CITY OF ALBUQUERQUE

**RE: Lot 15 Block 4 Unit 22 Volcano Cliffs SAD 228
6423 Canavio St.NW
Grading and Drainage Plan
Engineers Stamp Date 4/27/17 (D10D003D15)
Pad Certification Dated 6/26/17**

DRAINAGE AND TRANSPORTATION INFORMATION SHEET (REV 09/2015)

ENGINEER'S SEAL 4/27/17 DAVID SOULE P.E. #14522	6423 CANAVIO PLACE	DRAWN BY WCWJ DATE 4-26-17 21731-LAYOUT-4-26-17
	GRADING AND DRAINAGE PLAN 1606 CENTRAL AVENUE SE SUITE 201 ALBUQUERQUE, NM 87106 (505) 872-0999	SHEET # — JOB # 21731

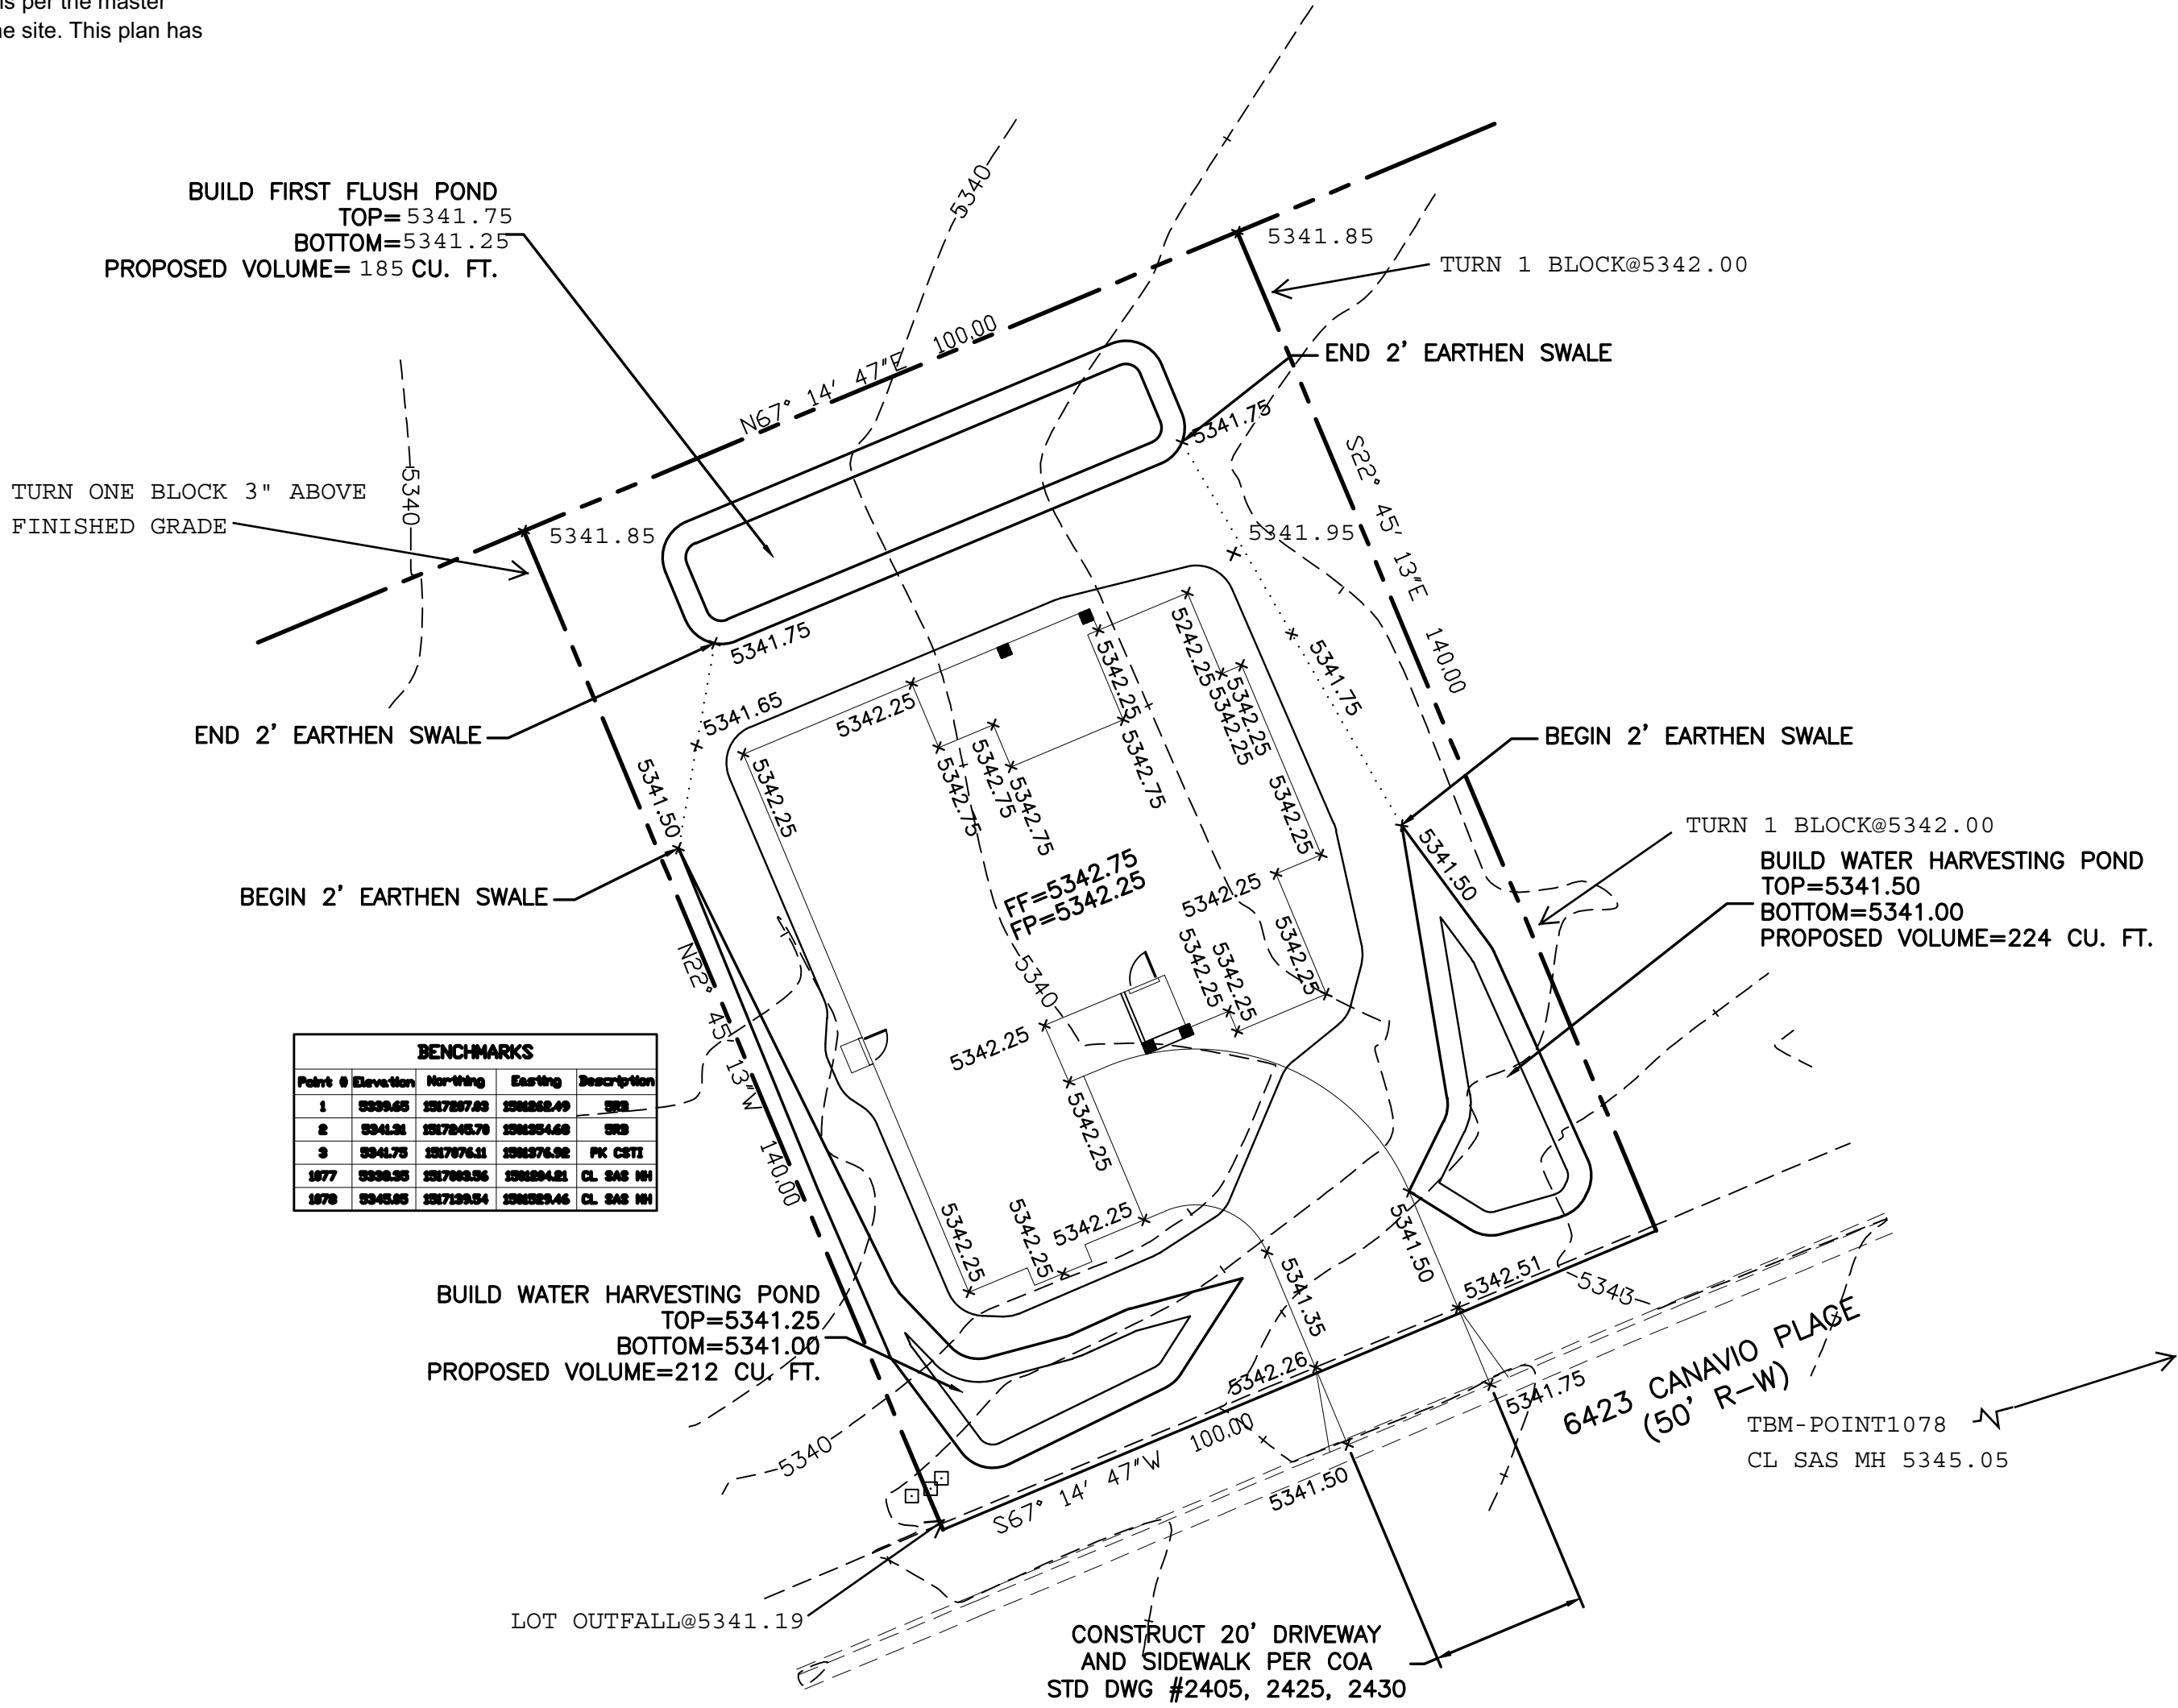
Based upon the information provided in your submittal received 6/27/17, this plan is approved for Building Permit.

Please inform the builder to attach a copy of this approved plan to the construction sets in the permitting process prior to sign-off by Hydrology. Also, notify the owner/contractor that a separate permit for any fence is required, and this is the plan to be used for the placement of the fence.

Prior to Certificate of Occupancy release, Engineer Certification per the DPM checklist of this plan will be required.
